Your Ref
F/4/18/PL
Our Ref
PLAN-022342
Date
19/04/2018

Proposal: Salt storage building, office building, parking & turning area & open storage areas for highways maintenance depot - This is a Departure from the Development Plan
Site: Land to the South of Ford Lane Ford BN18 0DF
F/4/18/PL

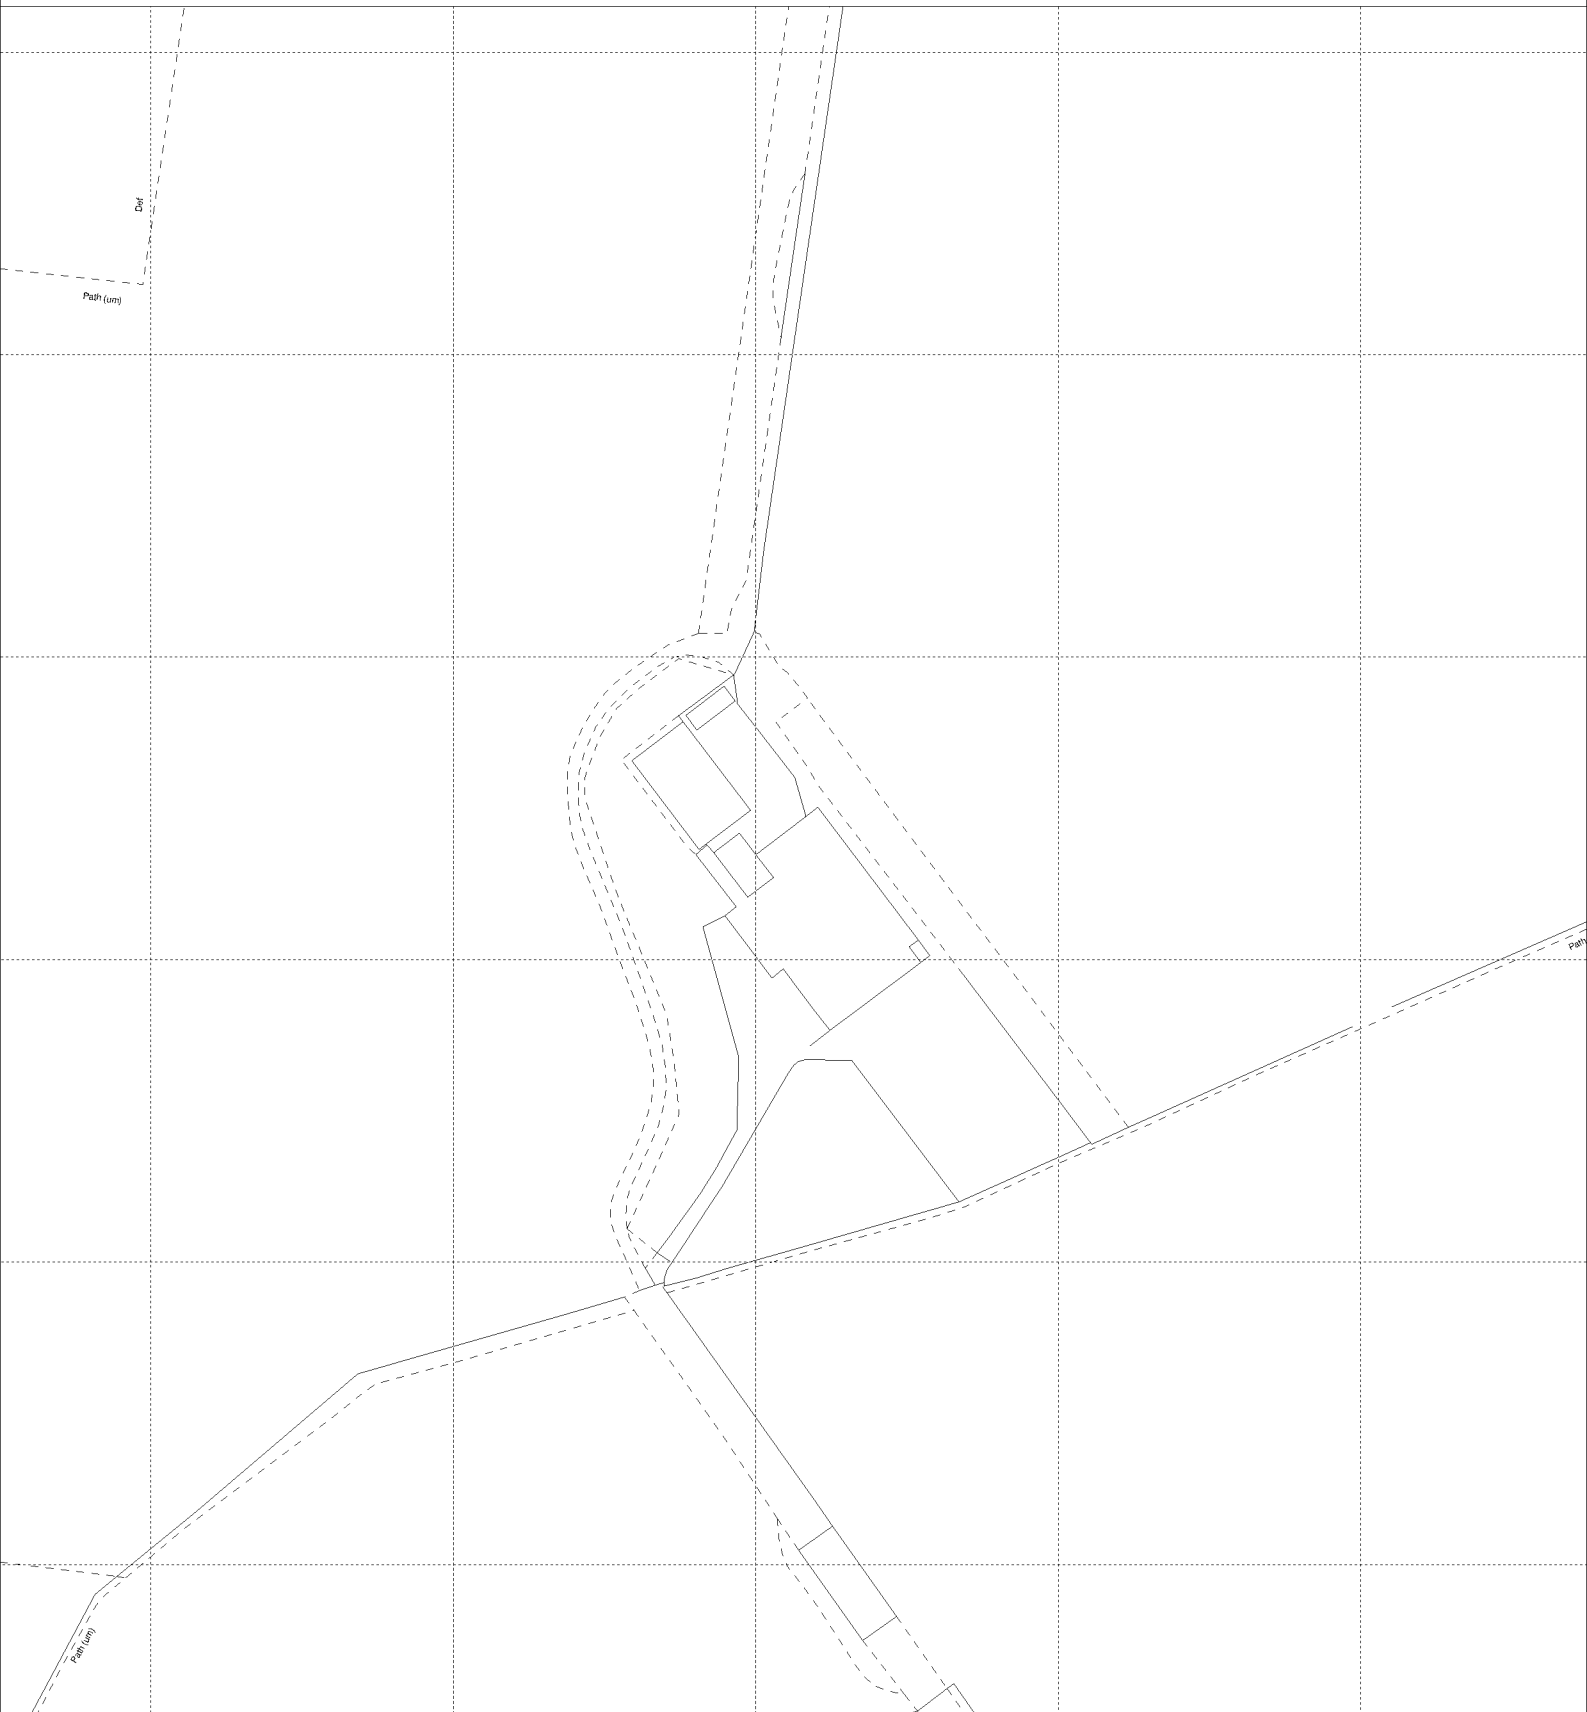
Due to surface water inundation issues in the Lidsey Catchment "The applicant is advised to adopt, where appropriate, the measures in the table "Practical measures to reduce the potential impacts of development".

Developer should look to protect the public sewerage system from inundation and infiltration, which contribute to flooding in unfavourable conditions.
